**TOWN OF NEWBURGH
PLANNING BOARD
TECHNICAL REVIEW COMMENTS**

PROJECT NAME: 17K VINEYARDS & SPIRITS
PROJECT NO.: 2024-21
PROJECT LOCATION: SECTION 86, BLOCK 1, LOT 12
REVIEW DATE: 13 SEPTEMBER 2024
MEETING DATE: 19 SEPTEMBER 2024
PROJECT REPRESENTATIVE: LOU DUBOIS, PE

274 ROUTE 17K SITE PLAN
SCALE: 1/8"=1'-0"

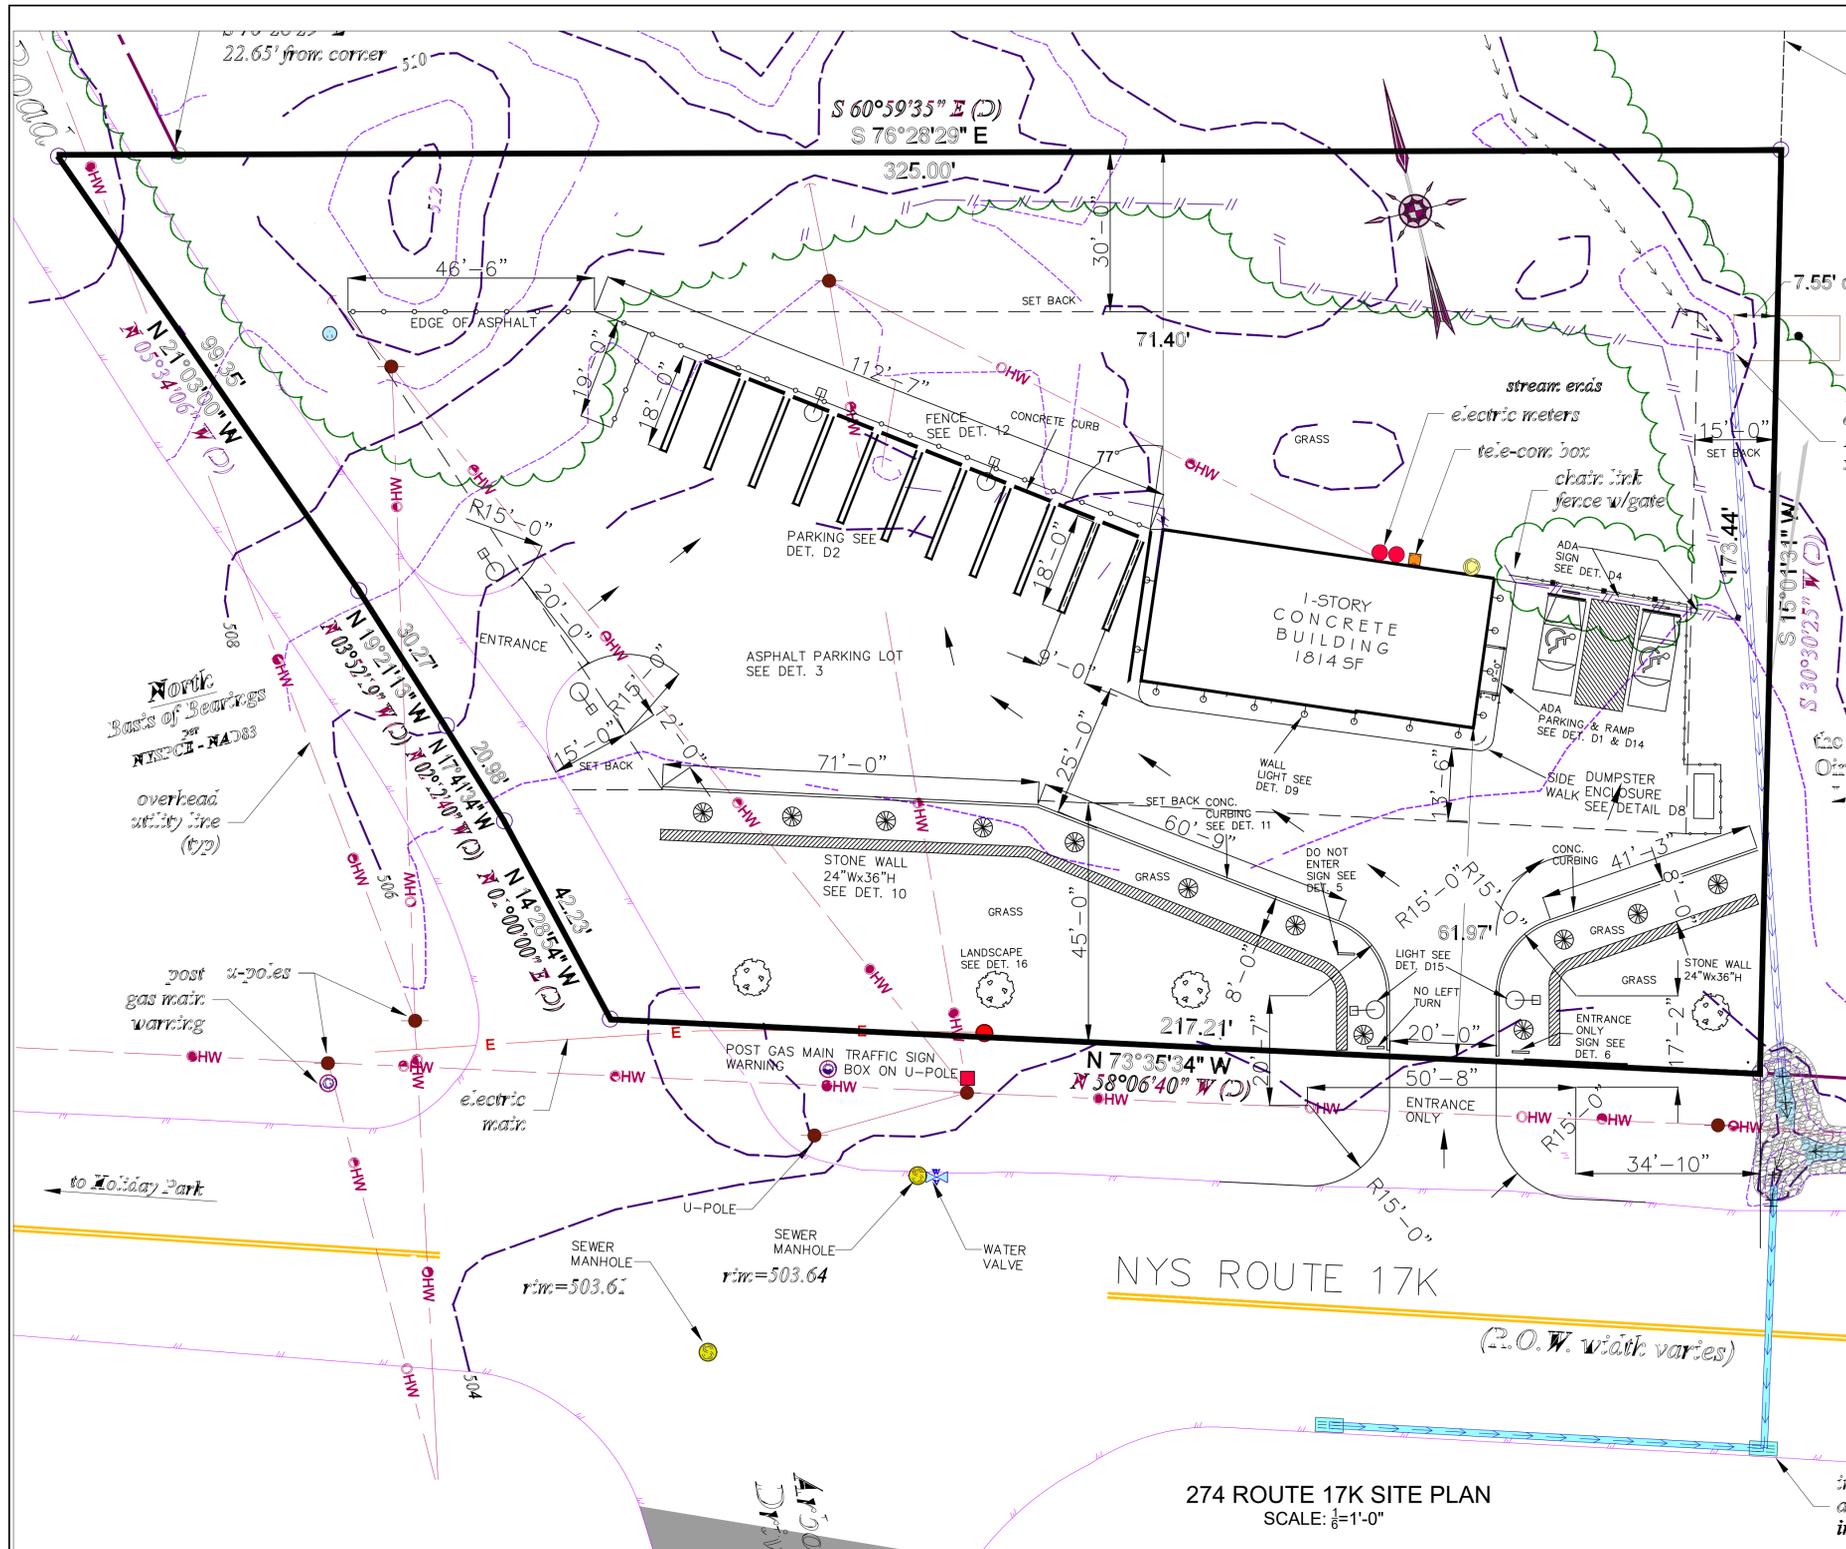
1. The site plan has been revised to reduce the amount of parking proposed on the site. Parking spaces are now proposed.
2. NYSDOT approval for the access drives are required.

5. A stone wall feature has been added to the 17K frontage.
6. A PVC fence is proposed along the parking stalls depicted on the western portion of the site.

7. County Planning referral is required as this project is located on a state highway.
8. ARB approval for the structure is required.
9. The applicant's representative has requested to address the asphalt pavement section proposed utilizing porous pavement with 6-inch-thick stone drainage layer. Underlying soil should be evaluated for permeability for the porous pavement to function.

13. Limits of disturbance on the site should be clearly identified to document the .5 acres disturbance in the EAF.
14. Confirmation of utilities serving the site including water and sewer should be identified on the plans.
15. Page 15 the bottom Section iii should be completed.
16. Hours of Operation Section on Page 7 should be completed.
17. Section Eb should be completed.
18. Section E2 should be completed.
19. Page 12, Page M Remove Indiana Bat from this section as it is addressed in Section O below.
20. The EAF should be appropriately signed on Page 13.
